HISTORIC AND DESIGN REVIEW COMMISSION

August 17, 2022

HDRC CASE NO: 2022-415
ADDRESS: 121 GLORIETTA
LEGAL DESCRIPTION: NCB 576 BLK 15A LOT E 30 FT OF 10
ZONING: RM-4, H
CITY COUNCIL DIST.: 2
DISTRICT: Dignowity Hill Historic District
APPLICANT: Felix Ziga/Ziga Architecture Studio PLLC
OWNER: Bob Prado/Delafield Investment LLC
TYPE OF WORK: Exterior modifications, fenestration modifications, construction of a rear addition, driveway installation, rehabilitation
APPLICATION RECEIVED: July 29, 2022
60-DAY REVIEW: Not applicable due to City Council Emergency Orders
CASE MANAGER: Edward Hall
REQUEST:

EXISTING & PROPOSED
SITE / ROOF PLANS

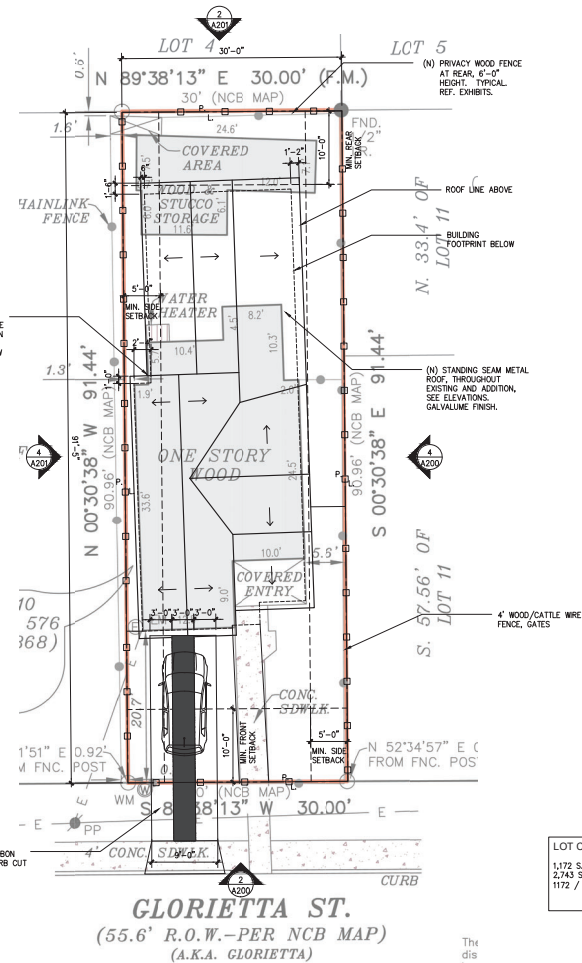
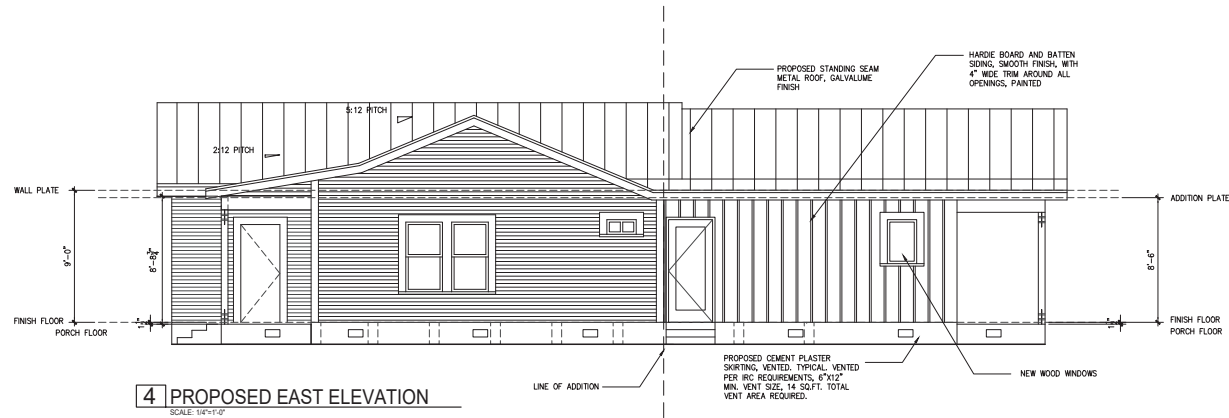
- o. DRIVEWAY – The current lot does not feature a driveway, and there is no curb cut in place. The applicant has proposed to install a concrete ribbon strip driveway to feature nine (9) feet in width to terminate at the front façade of the historic structure. The Guidelines for Site Elements 5.B.i. notes that new driveways should have a similar driveway configuration as those found historically on site. The Guidelines for Site Elements 7.a.ii. notes that off-street parking should not be installed within the front yard streetscape as to not disrupt the continuity of the block. Staff finds the proposed driveway configuration to be inconsistent with the Guidelines; however, staff notes that there is not space on site to locate a driveway as they are recommended by the Guidelines. Staff finds that a driveway that is moved to the east property line may be appropriate as this would result in a more offset front yard parking condition.

8. Staff does not recommend approval of item #8, the installation of a driveway, as noted in finding o, as proposed. Staff recommends that the driveway be moved to the east property line as this would result in a more offset front yard parking condition.

EXISTING & PROPOSED EXTERIOR ELEVATIONS

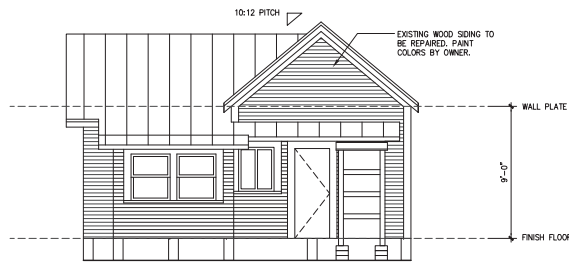
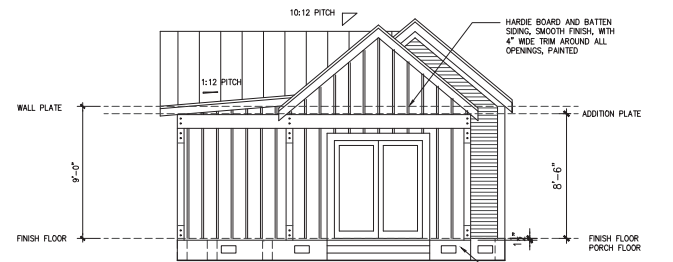
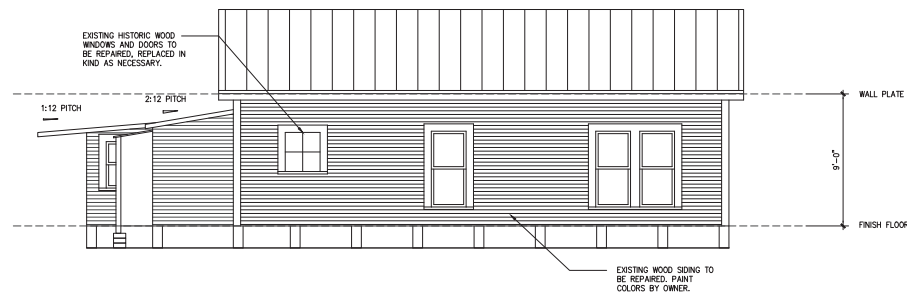
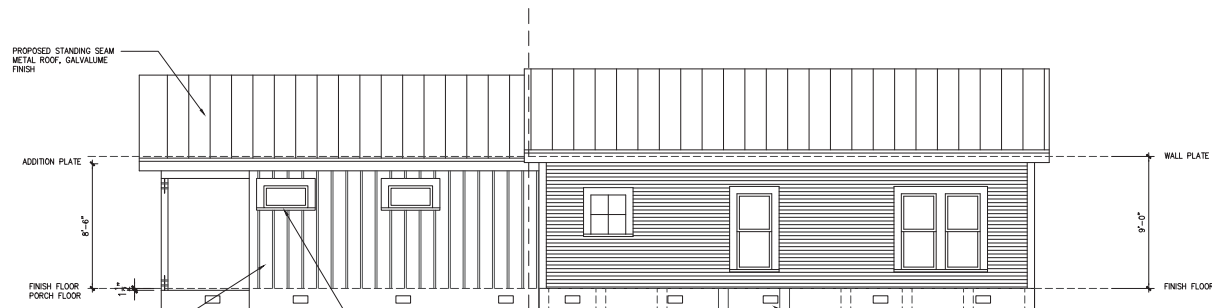
- i. REAR ADDITION – The Guidelines for Additions 1.A. notes that additions should be sited to minimize view from the public right of way, should be designed to be in keeping with the existing, historic context of the block, should feature similar roof forms, and should feature a transition to differentiate the new addition from the historic structure. Additionally, the Guidelines for Additions 1.B notes that additions should be subordinate to the principal façade of the historic structure, should feature a footprint that responds to the size of the lot, and should feature an overall height that is generally consistent with that of the historic structure. Generally, staff finds the proposed addition to be appropriate and consistent with the Guidelines; however, staff finds that the overall height of the rear addition should be reduced to ensure that the ridgeline is subordinate to that of the historic structure.

- l. ROOF FORM – The applicant has proposed for the rear addition to feature both a rear facing gabled roof and a side facing shed roof. Staff finds the proposed roof form to be appropriate and consistent with the Guidelines.

- m. ARCHITECTURAL DETAILS – As noted in the above findings, staff finds that the proposed addition's ridge height should be lowered to be subordinate to that of the historic structure and that windows should be modified to feature profiles that are comparable to those found historically on the primary structure.

- i. That the overall height of the rear addition be reduced to ensure that the ridgeline is subordinate to that of the historic structure.
 - ii. That the standing seam metal roof feature smooth panels that are 18 to 21 inches wide, seams that are 1 to 2 inches in height, a crimped ridge seam and a standard galvalume finish. A red finish may also be installed.

- iv. That the proposed windows be modified to feature profiles that are consistent with those found historically on the primary historic structure on the lot. All windows should be consistent with staff's standards for windows in new construction and additions.
